# TEXAS WOMAN'S UNIVERSITY™

## Procurement & Contracts

**Below is a list of Request for Information (RFI) items related to above referenced RFP:**

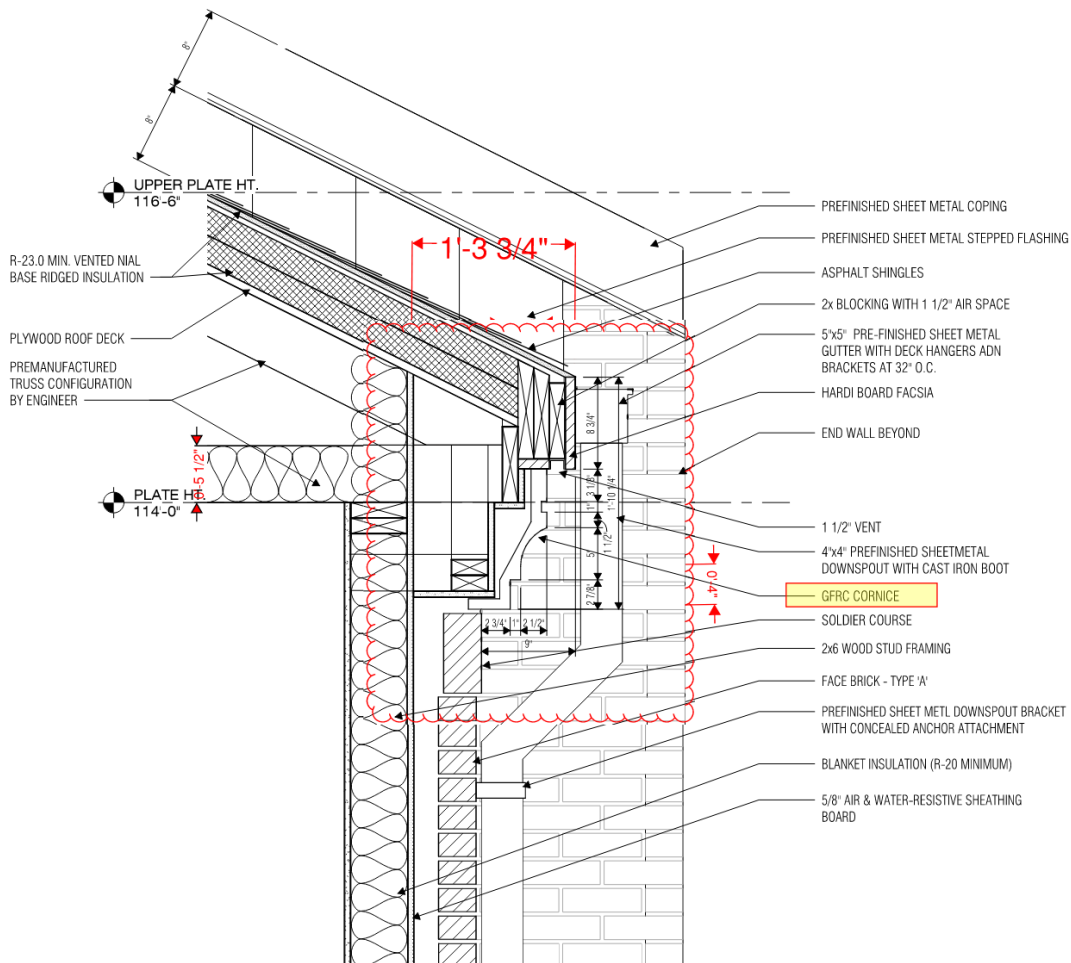
- Are the interior aluminum door frames storefront as detail H4/A7.11 shows or are they Frameworks type 2 as called out in the specs? **See Addendum 02 for specification**
- Is there a BOD for the impact resistant glazing type CI1 and CI2? School Guard?

3 WALL SECTION - BACK WALL - ROOF  
SCALE: 1 1/2" = 1'-0"

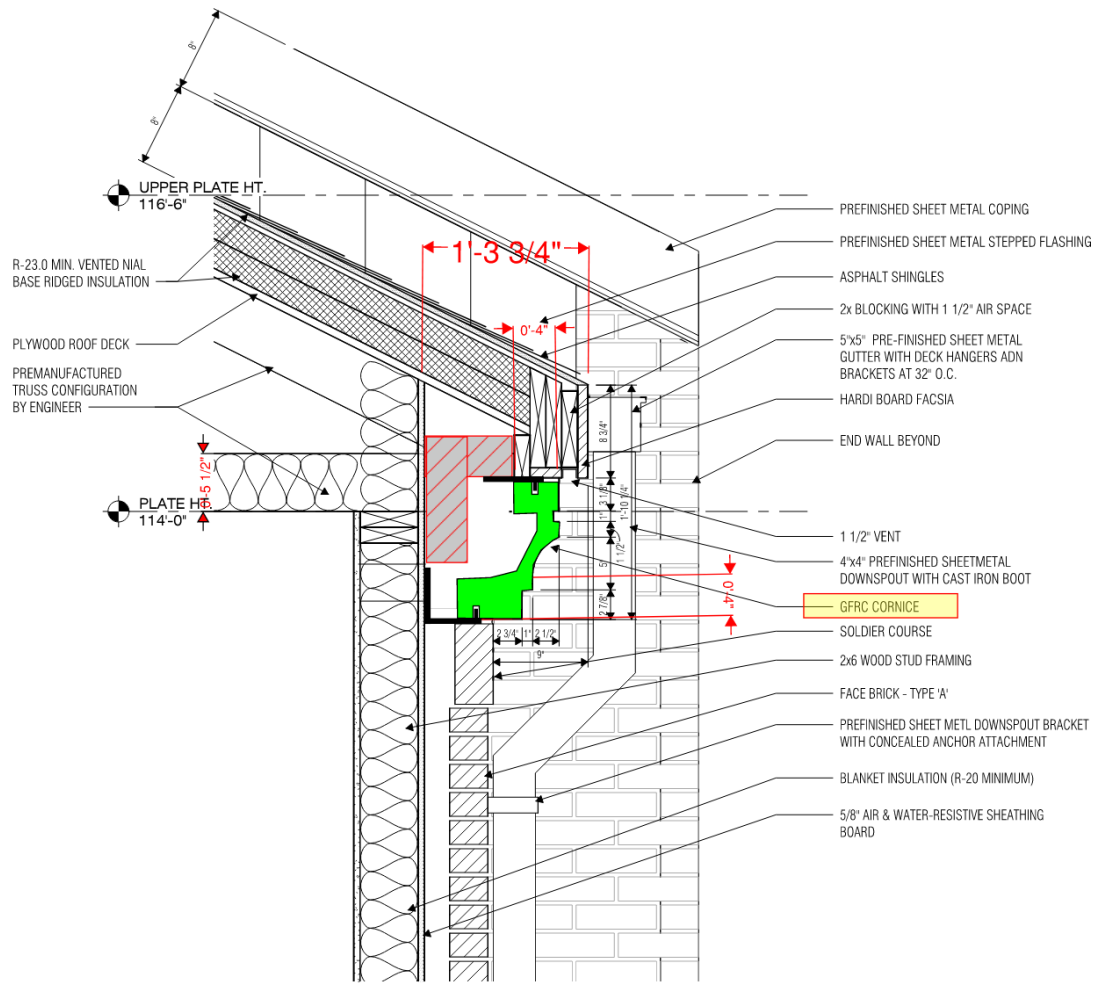
Please see for possible correction below **GFRC profile is shown for design intent. Engineering and final installation of GFRC to be reviewed as part of the submittal process.**

**Possible correction:**
